L-2000-028  
10 CFR §50.90

Re: Turkey Point Units 3 and 4  
Docket Nos. 50-250 and 50-251  
Proposed License Amendments  
"Revised Pressure/Temperature (P/T) Curves, and  
Cold Overpressure Mitigation System (COMS) Setpoints"

## ATTACHMENT 1

### 3.0 PROPOSED TECHNICAL SPECIFICATION CHANGE REQUEST

FIGURE 3.4-2

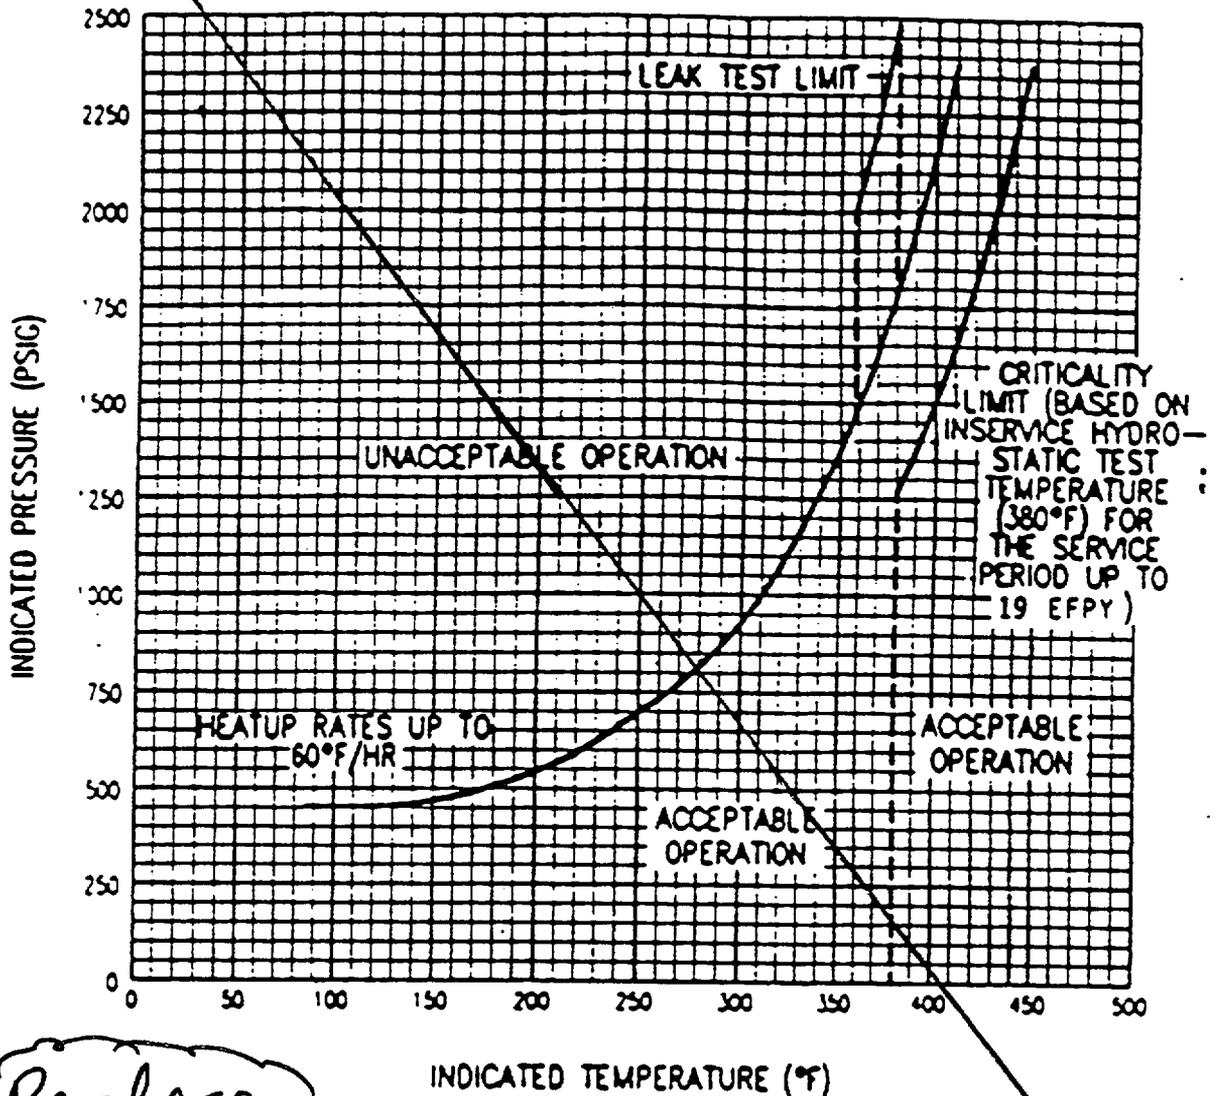
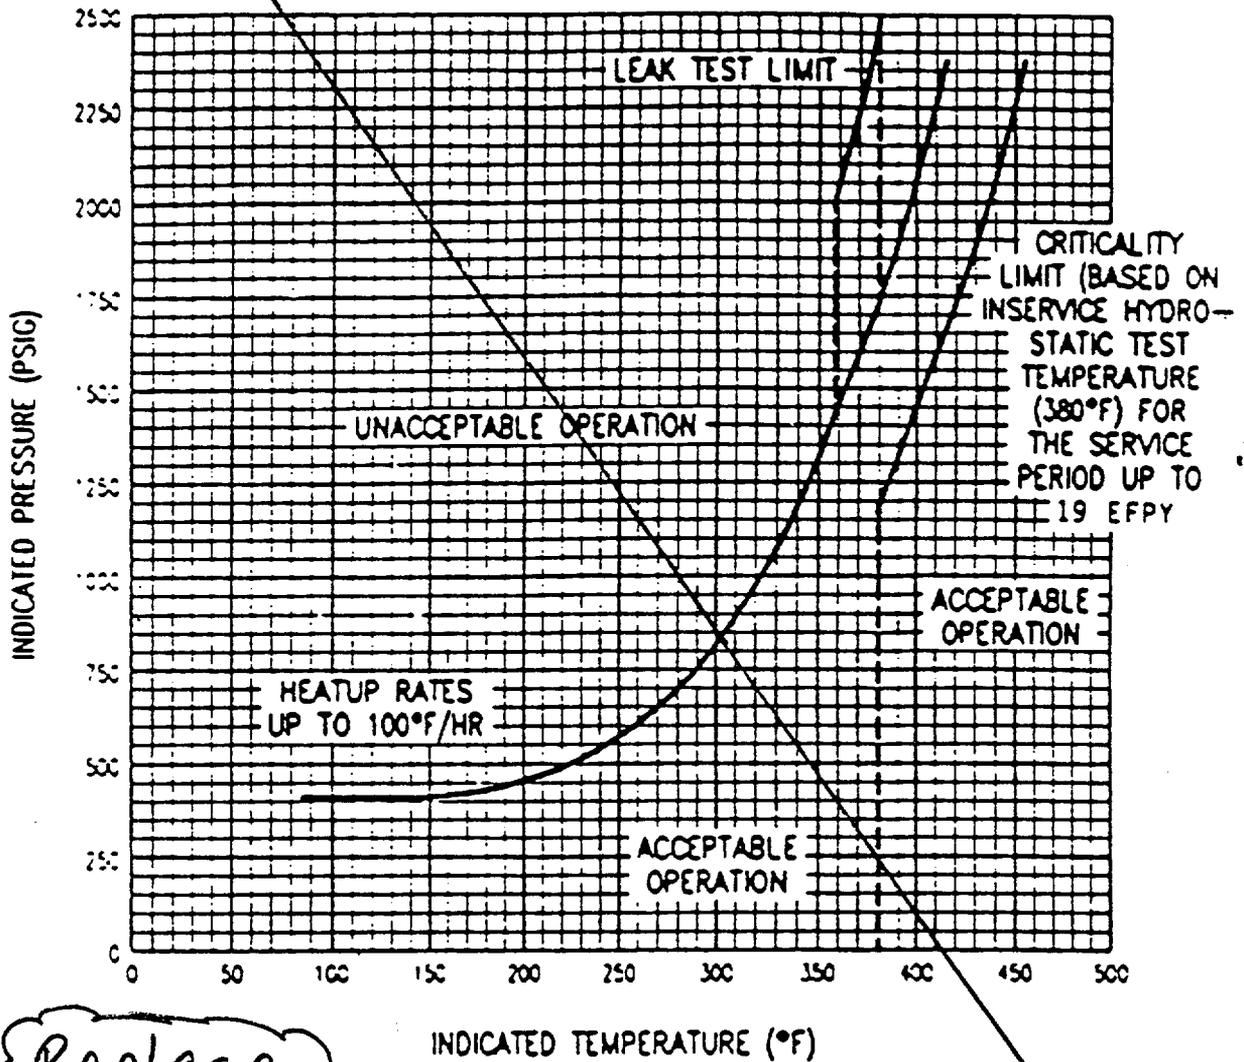
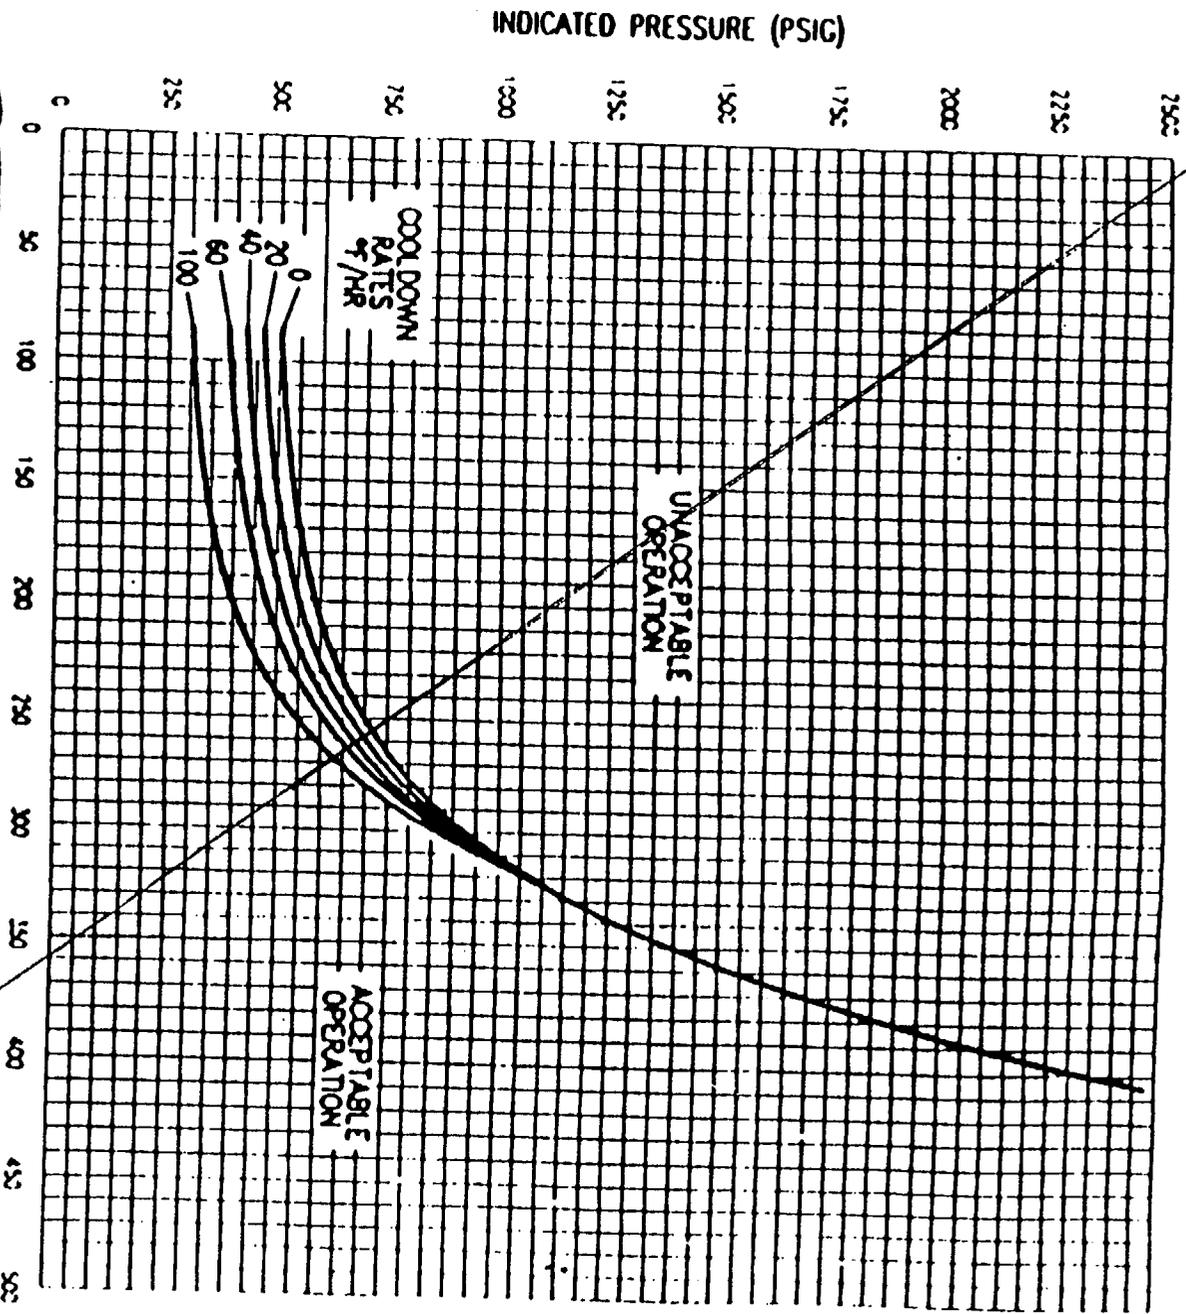
- e) **Technical Specification Figures 3.4-2, 3.4-3, and 3.4-4: Replace these three current figures with two new Figures 3.4-2, and 3.4-3, to reflect the Pressure/temperature Limits applicable for the service period up to 32 EFPY, as opposed to the present 19 EFPY.**

Discussion: The 32 EFPY curves replace the 19 EFPY curves. The new heatup curves have the 60 °F/hour and 100 °F/hour rates on one sheet. The 19 EFPY curves were separate for each heatup rate. The curves themselves have no instrument uncertainty built in but the associated COMS setpoint does have the uncertainty margin included. The new curves are complete to minimum bolt-up temperature whereas the 19-year curves stopped at 80 °F. The 32 EFPY curves have a compound slope which shows the effect of Code Case N-588. This slope reflects the fact that at low temperatures the forging with its assumed longitudinal reference flaw dominates because hoop stress dominates. The weld is limiting for most of the range.
